**COMMON COUNCIL
MEETING NOTICE AND AGENDA
Monday, October 2, 2023
6:30 PM**

Project Name: WVRC Conditional Use, Rezoning, and Site & Building Plans

WVRC comment response letter

IMPROVEMENT PLANS FOR WVRC EMERGENCY VET CITY OF PEWAUKEE, WI

C403

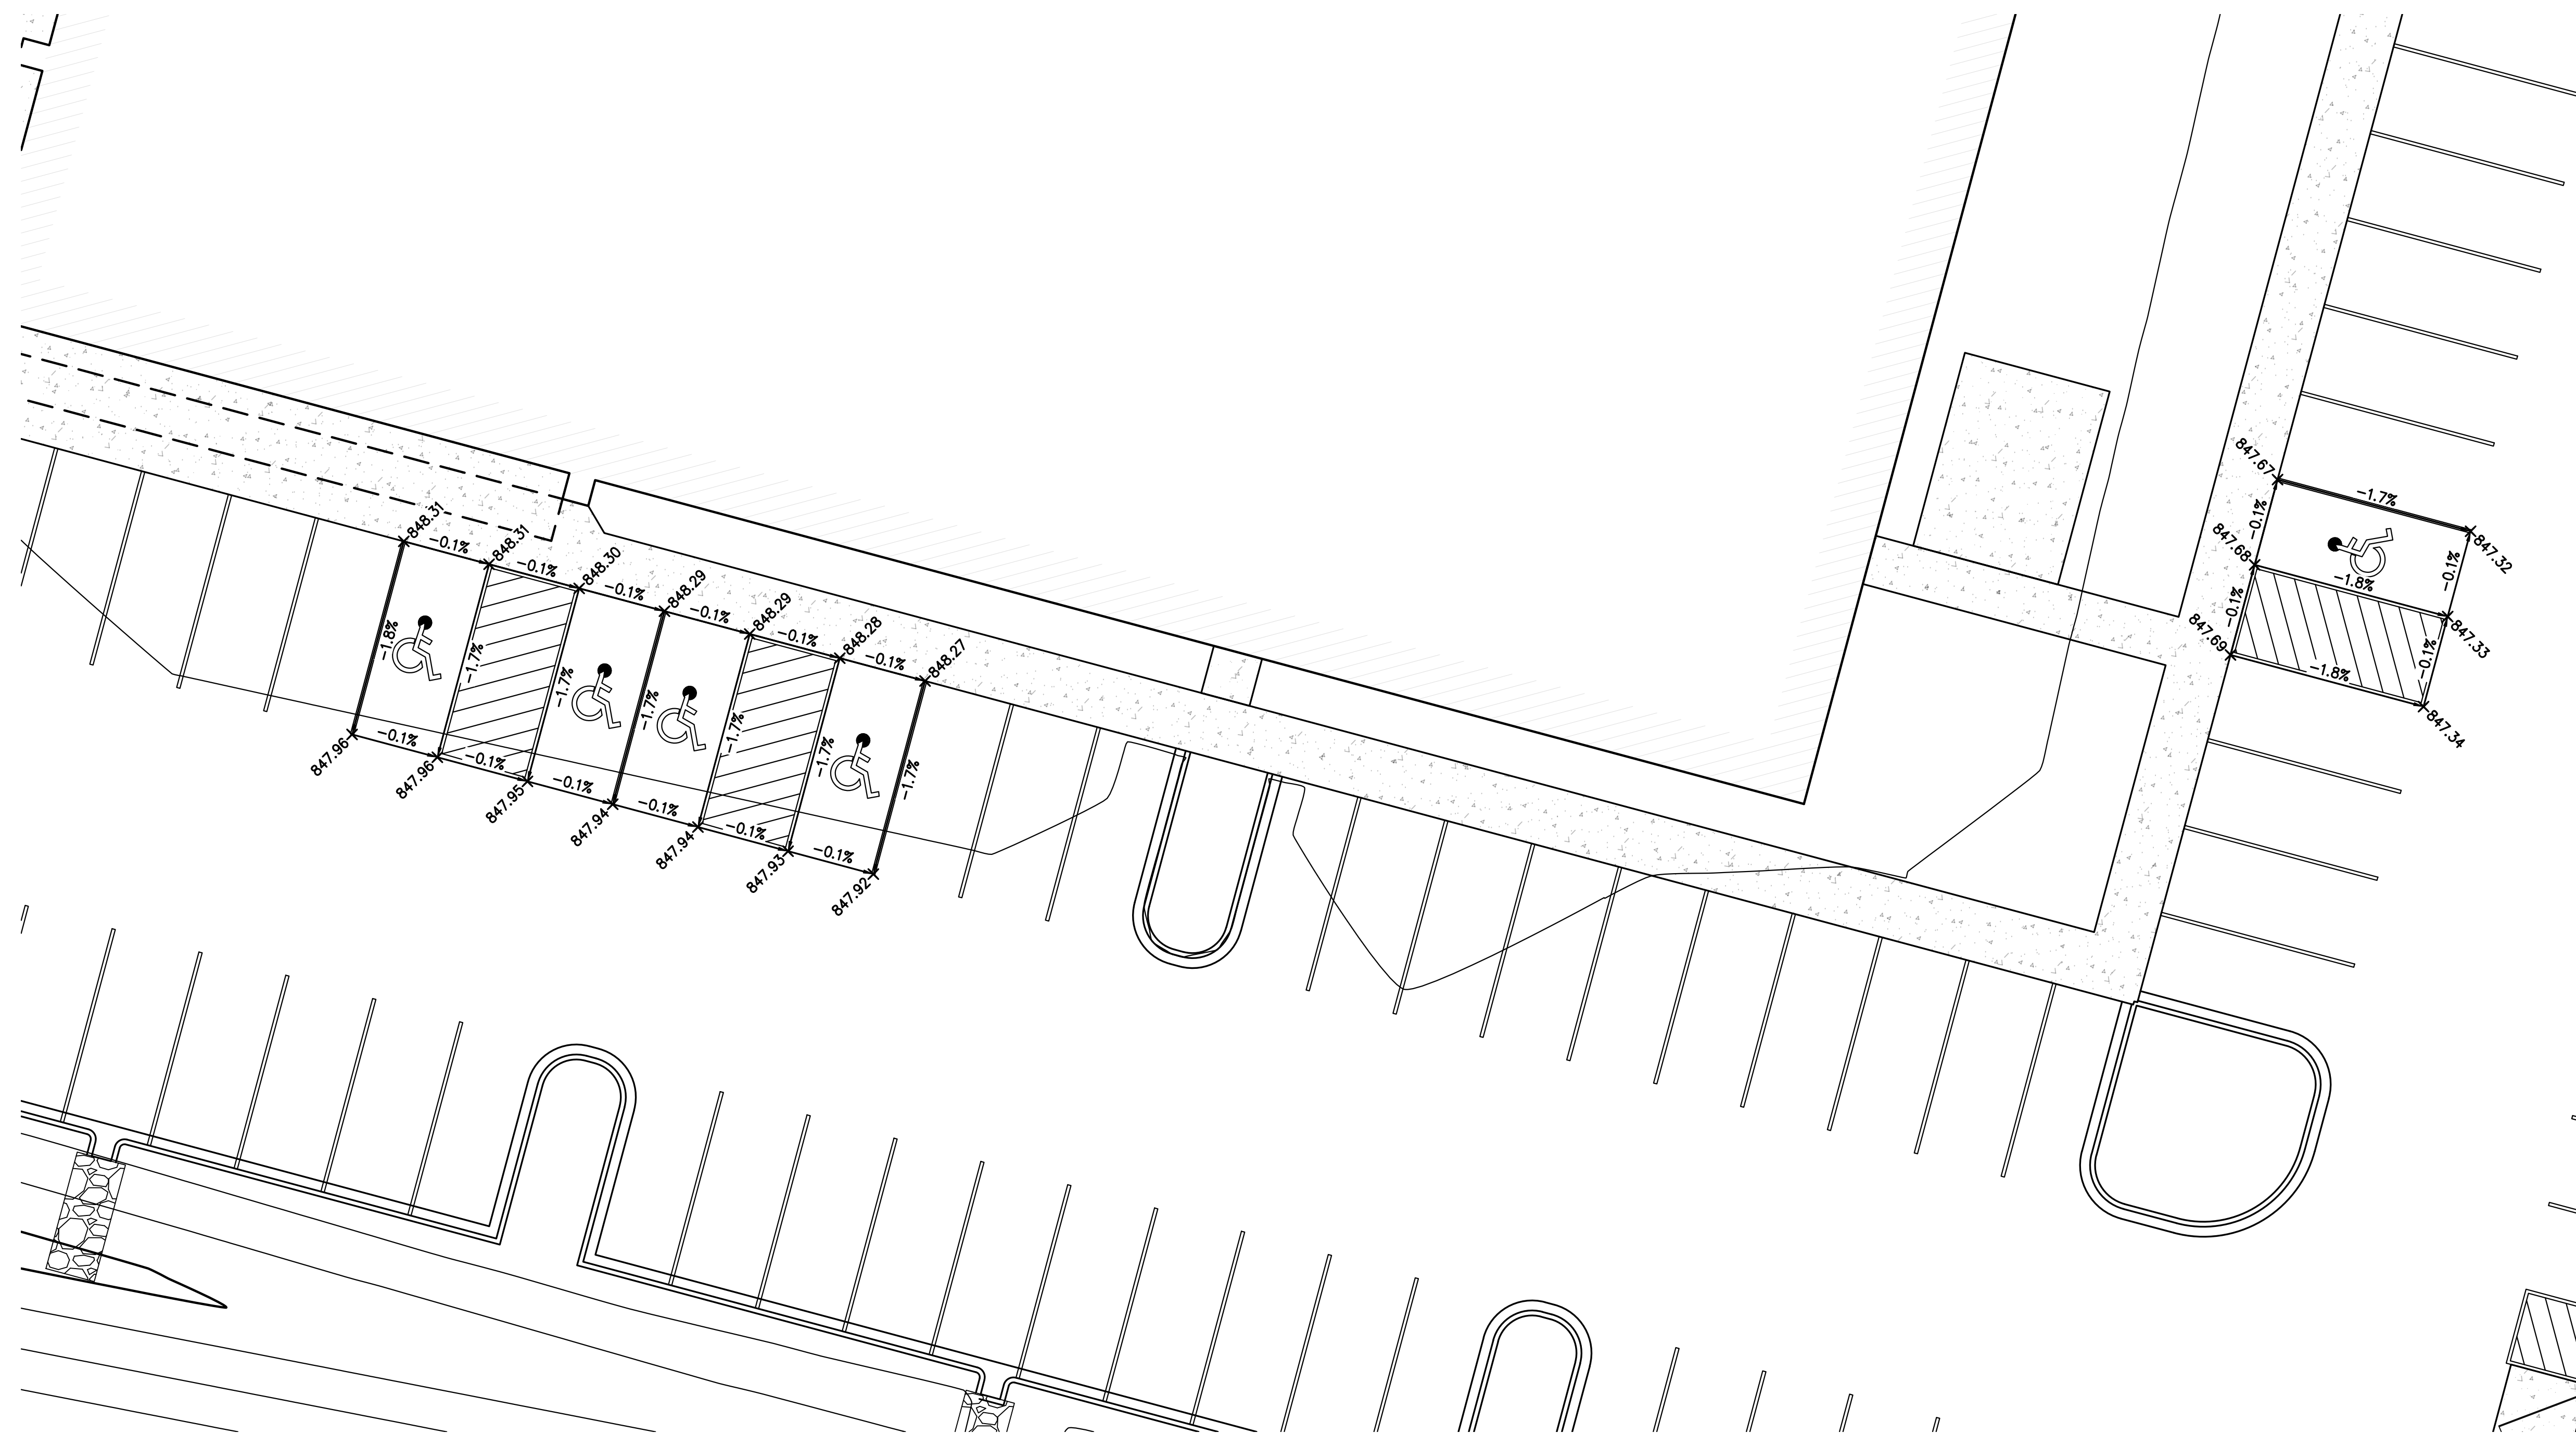
Sheet C404 – Intersection Detail:

C501

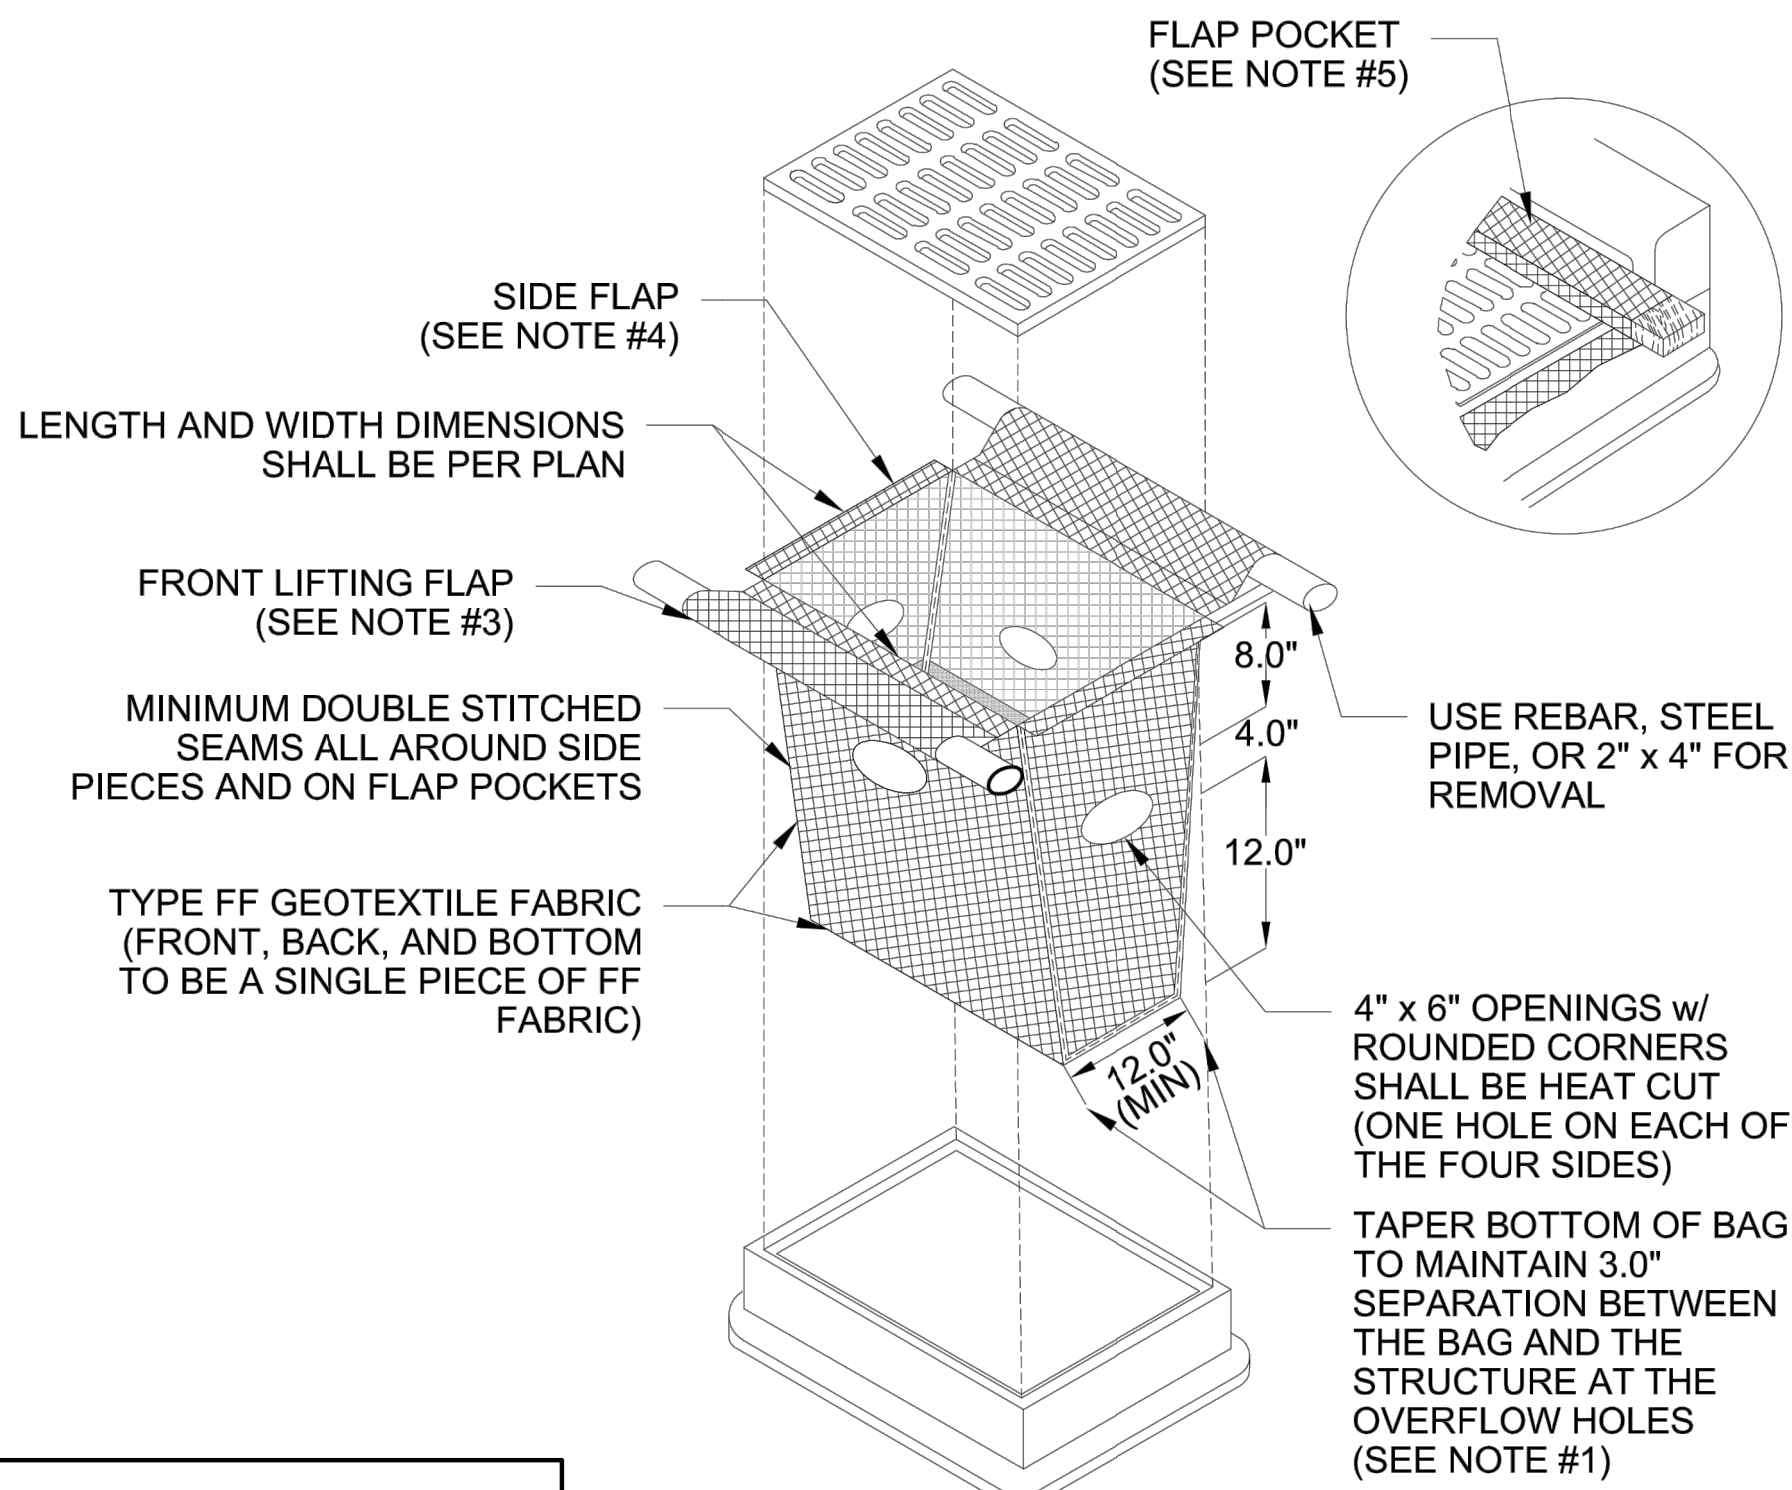
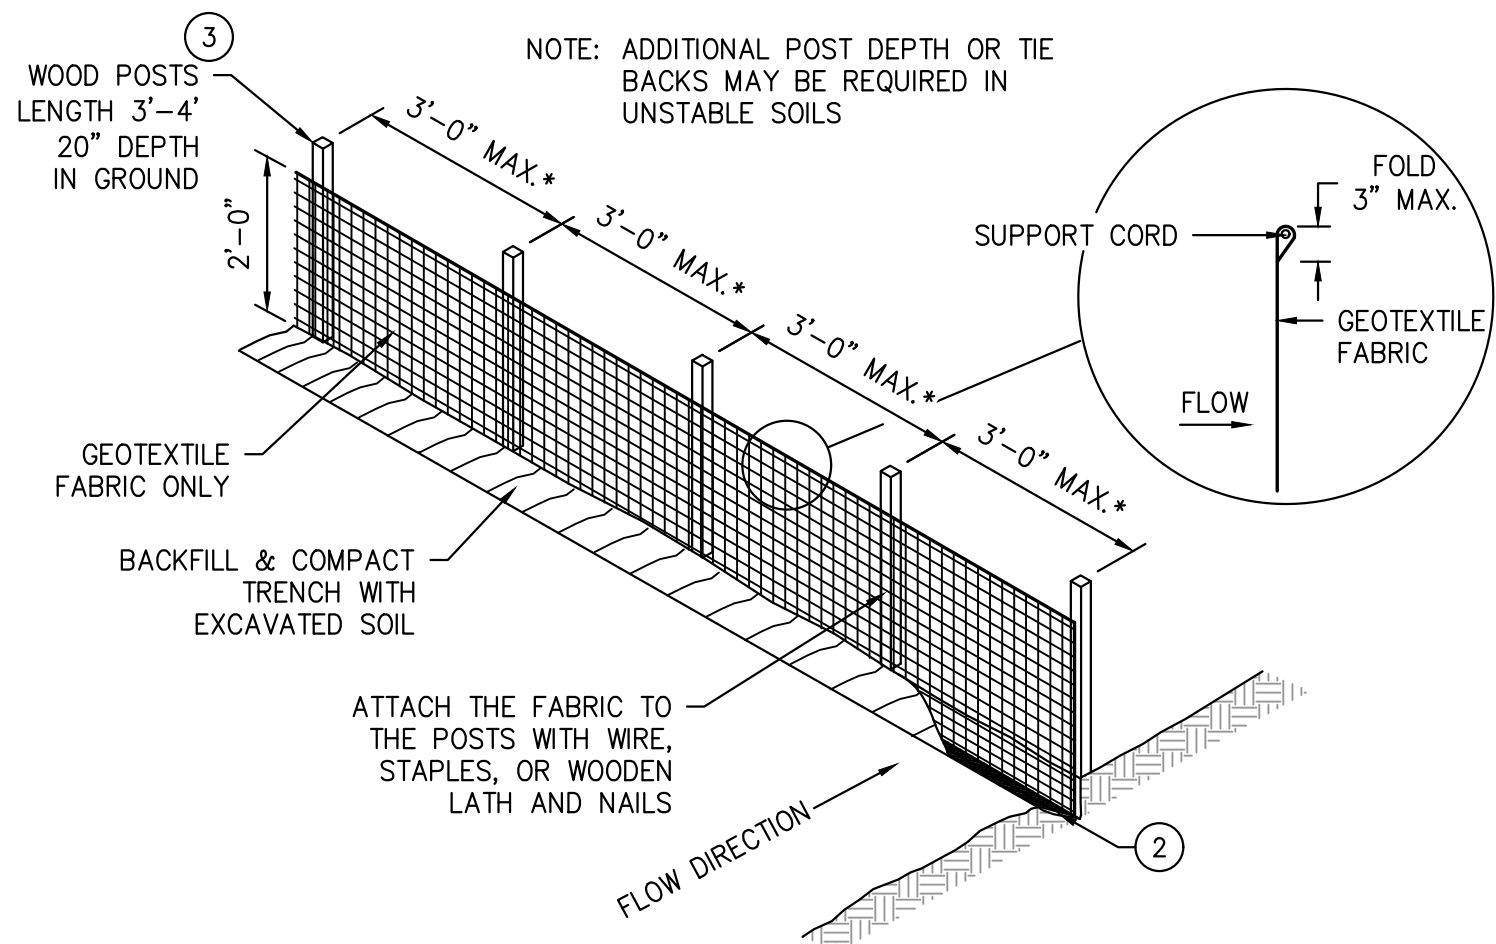
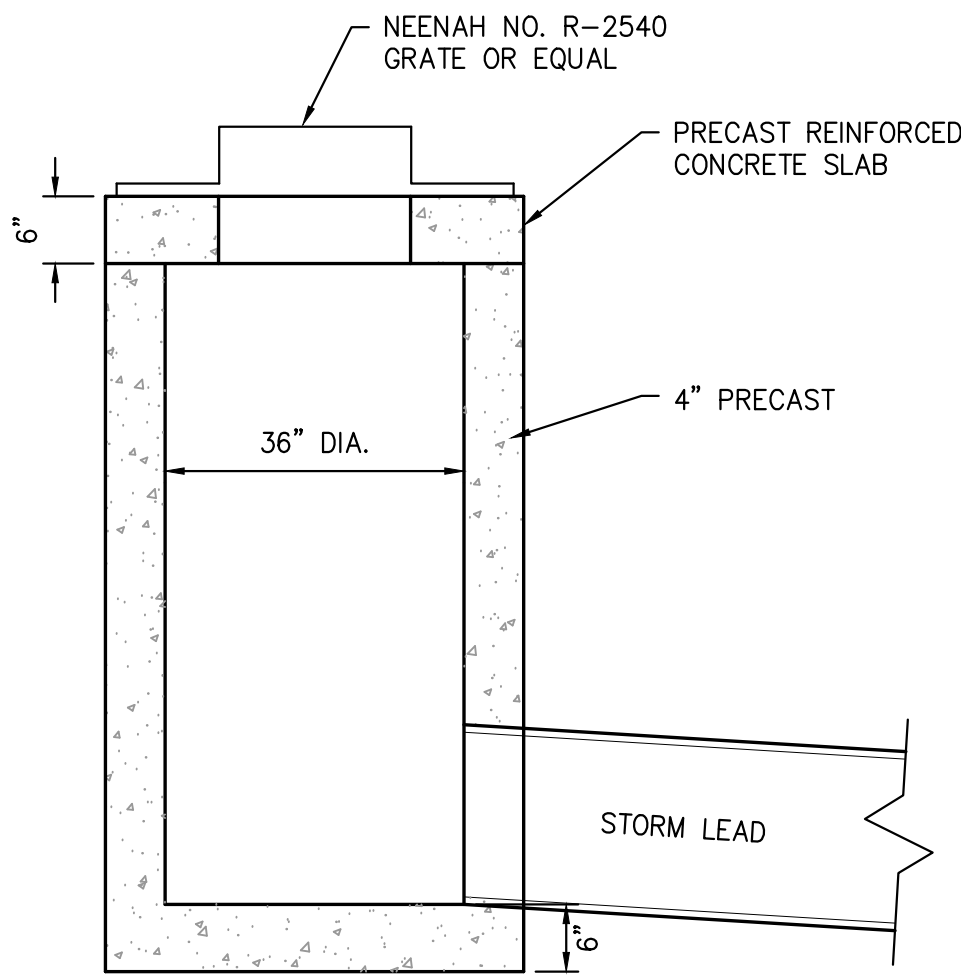
1. Show the location and details for the proposed concrete washout on site. **Concrete washout has been added to sheet C103, and a detail has been added to sheet C503.**
2. Revise inlet protection detail to show type A and type D inlet protection. All inlet protection placed on site should be type A or type D. **Inlet protections details for type A and D have been added to sheet C501.**
3. Include a detail for the proposed orifice trash grate. **Detail has been added to sheet C503.**
4. Revise the end section and riprap detail to show placement of medium riprap following the flared end section. **Detail has been updated from light riprap to medium riprap.**
